DEVIATION REQUEST FORM

Deviation Reference Number	DEV_255	
Date of decision	10/06/2022	
Precedent (YES/NO)	No	
Precedent details	N/A	
Date of submission	10/05/2022	
Project/PoA/VPA	Project	ID – GSXXXX
	<input checked="" type="checkbox"/> PoA	ID – GS1247 and 7591
	<input type="checkbox"/> VPA	ID – GSXXXX
Project/PoA/VPA title	GS1247 Improved Kitchen Regimes GS7591 International Programme of Safe Water and Efficient Cooking	
Location of project/PoA/VPA	Burkina Faso Eritrea Ethiopia Gambia Kenya Malawi Mozambique Rwanda Sierra Leone Togo Uganda Zambia Zimbabwe	
Scale of the project/PoA/VPA	<input checked="" type="checkbox"/> Microscale <input checked="" type="checkbox"/> Small scale <input type="checkbox"/> Large scale	
Gold Standard Impact Registry link of the project/PoA/VPA	https://registry.goldstandard.org/projects/details/155 https://registry.goldstandard.org/projects/details/2206	
Status of the project/PoA/VPA	<input type="checkbox"/> New <input type="checkbox"/> Listed <input checked="" type="checkbox"/> Certified design <input checked="" type="checkbox"/> Certified project

Title/subject of deviation	Deviation to ensure supply of safe water	
Specify applicable rule/requiremen

JMP Drinking Water Ladder

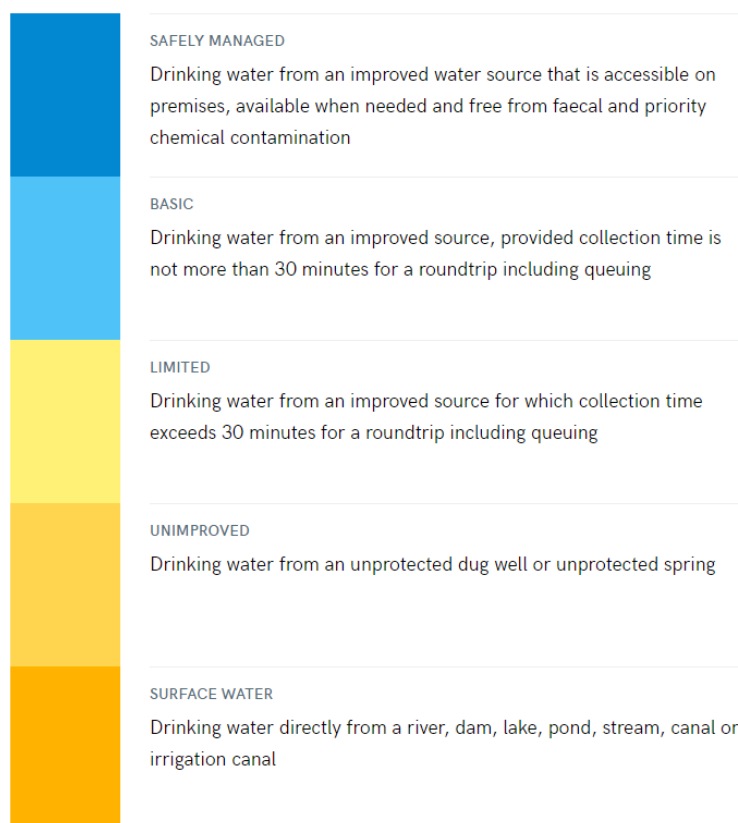
CO2balance are requesting a deviation from the 1km rule in SDWS. Instead, PD will monitor the number of users within 1km and over 1km, and report this as users with access to limited safe water supply and users with access to basic safe water supply:

The deviation requested for parameter SWDS 1 is **not approved**.

Since v2.0 of the methodology (previously TPDDTEC) published, a distance-based eligibility requirement is in place. This limitation on the eligibility of end-user is to ensure that the project provides access to safe water but also improves the accessibility where the end-user community is lacking even the basic access. Additionally, this eligibility criteria is also relevant since further the source of clean water is, the more likely the users are to be tempted to use unsafe water sources available in proximity since carrying water is an arduous task. Using unsafe water sources even occasionally negates or reduces the use of safe water on other days. The requested deviation will lock in the end-users in a baseline situation for accessibility for the entire crediting period. Therefore, the project developer is expected to improve the accessibility where needed to meet the basic service level definition.
